Noyac Bay

Suite 211
Inventory

SUITE 211 - NOVAC FV -

■ HAMPTON PLACE ■ 25 Baker Hill Bk

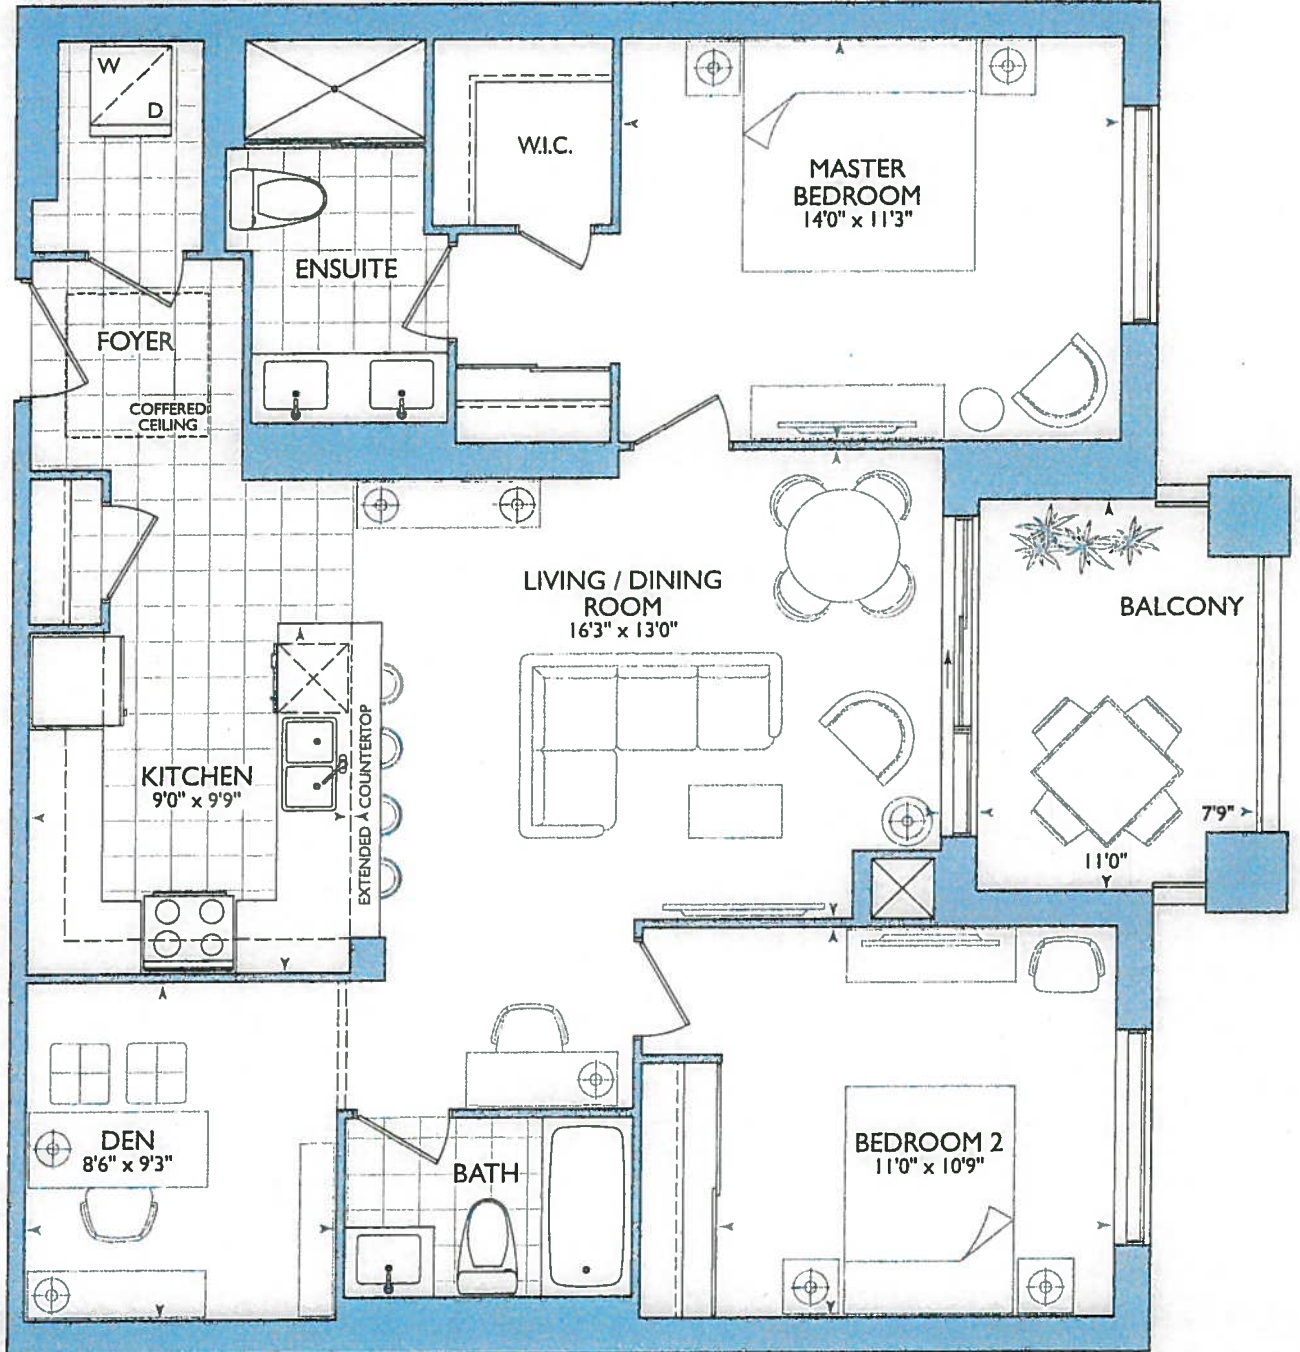
Laundry Door Swing
Revised As Per This Brochure.

* ENSUITE WALL BACKING
ONTO LAUNDRY AND FOYER
REVISED AS PER
THIS LAYOUT

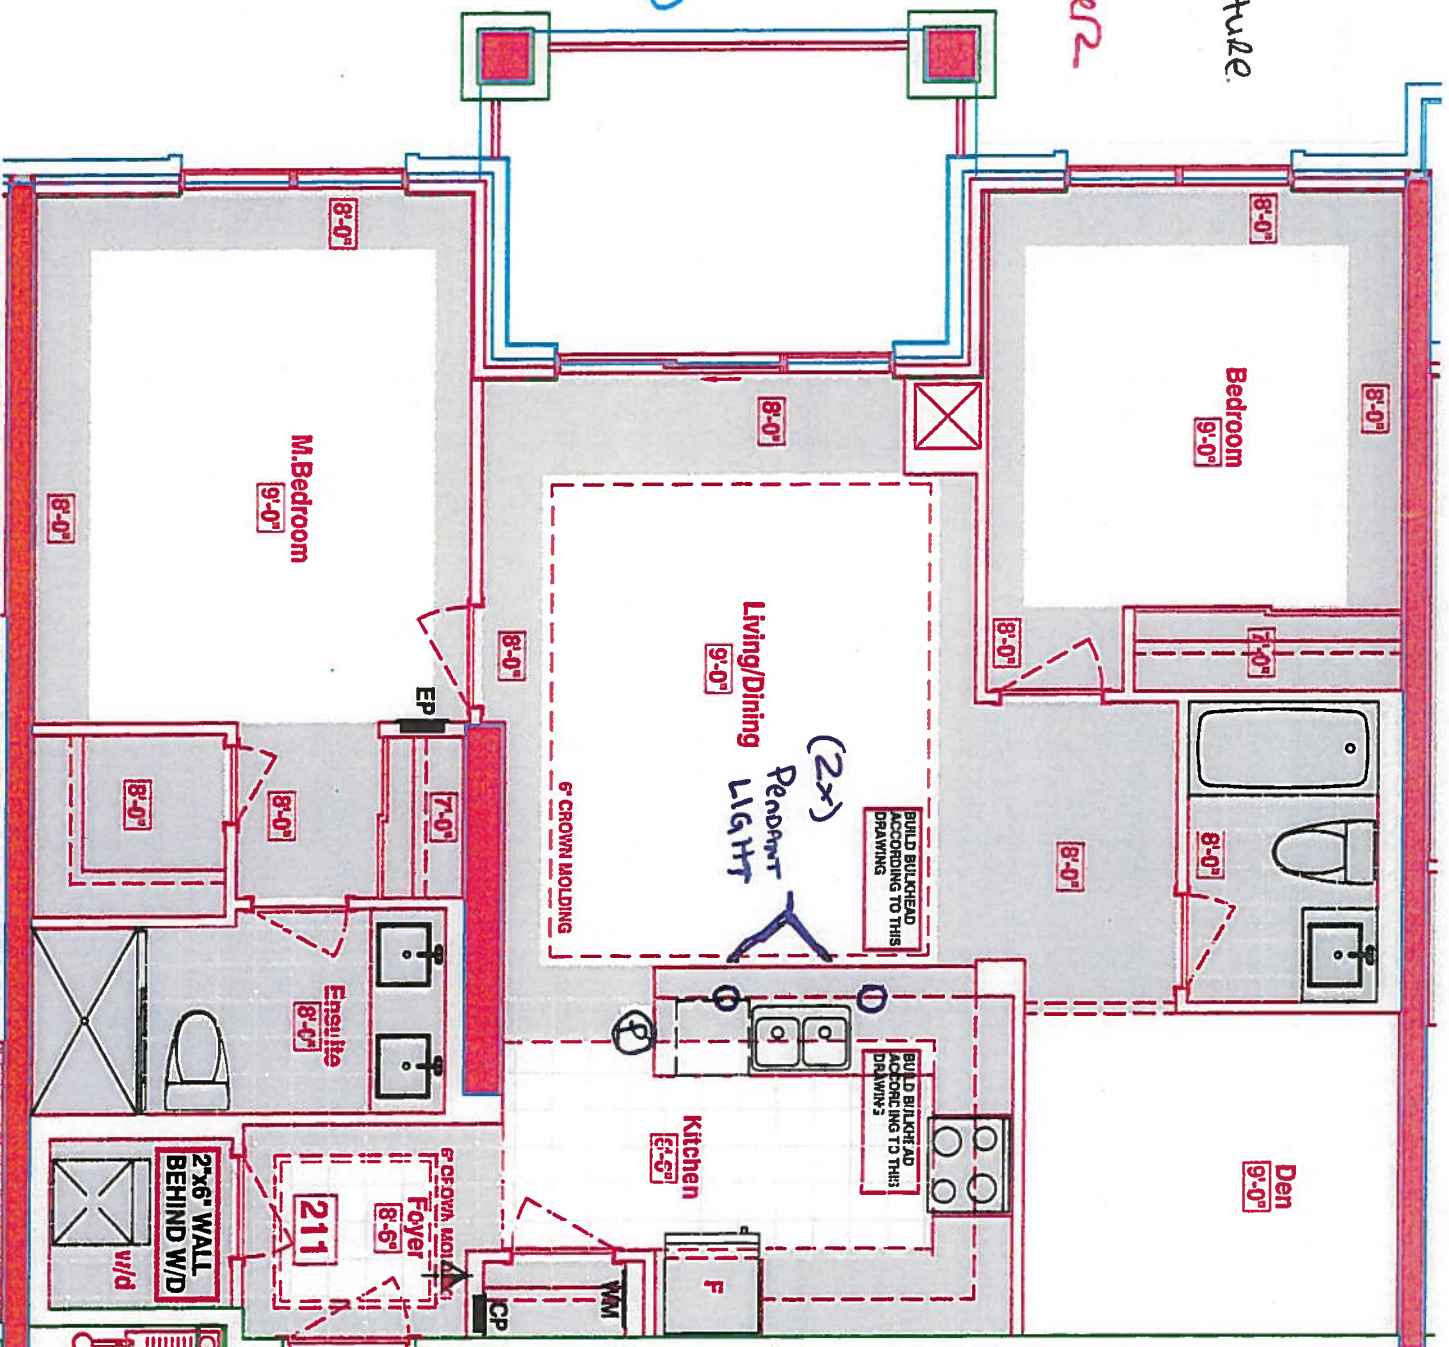
**6" WALL
BEHIND W/D**

**ELIMINATE JOG
AT FRIDGE WALL**

ROOM: KITCHEN FLOOR PLAN

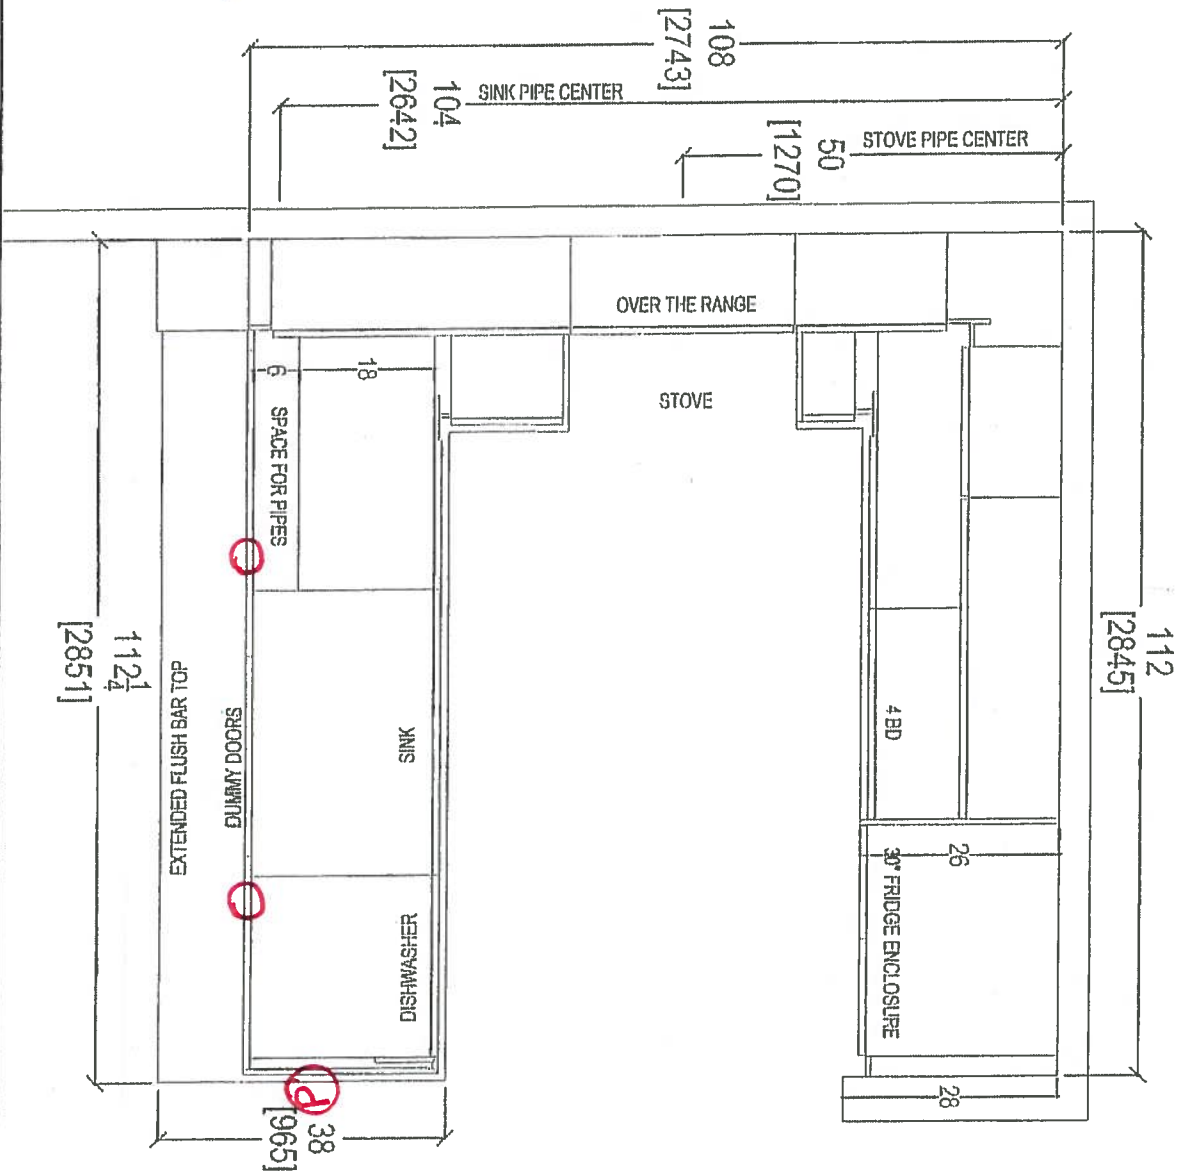
- Suite # 211- Kitchen LAYOUT
- STD APPLIANCE PACKAGE
- (2x) = PENDANT LIGHTS OVER PENINSULA
- (P) = PLUG PENINSULA

Suite #211- Kitchen LAYOUT

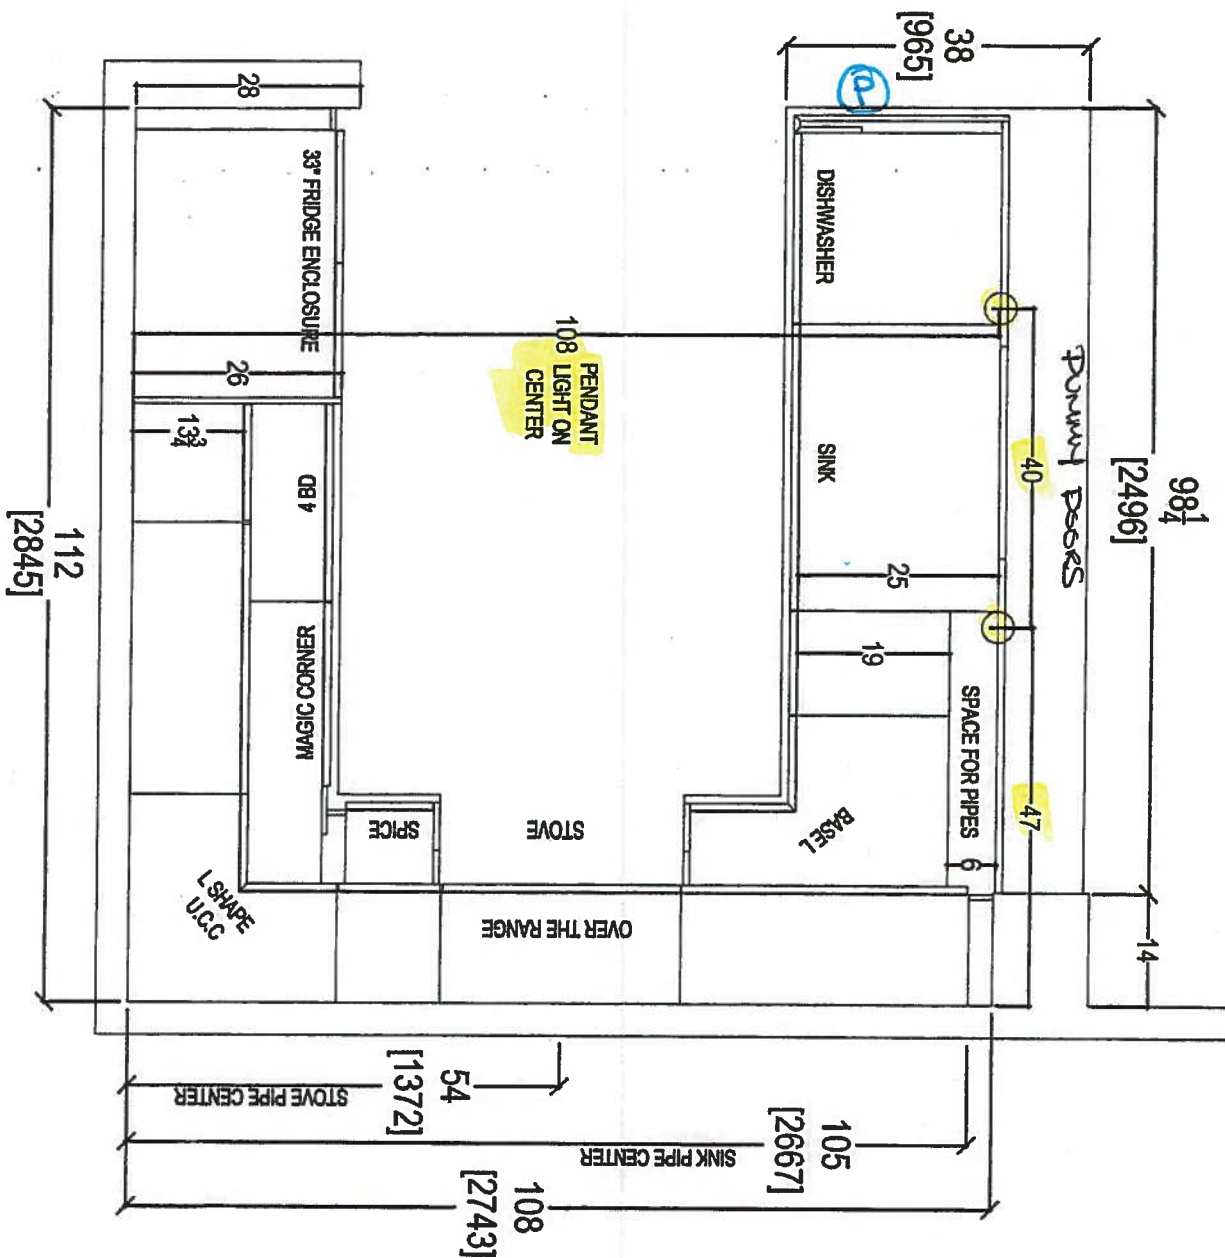
with - upgrade #1 - Appliance

PACKAGE

(2x) = PENDANT LIGHTS OVER Peninsula

(P) = PLUG Peninsula
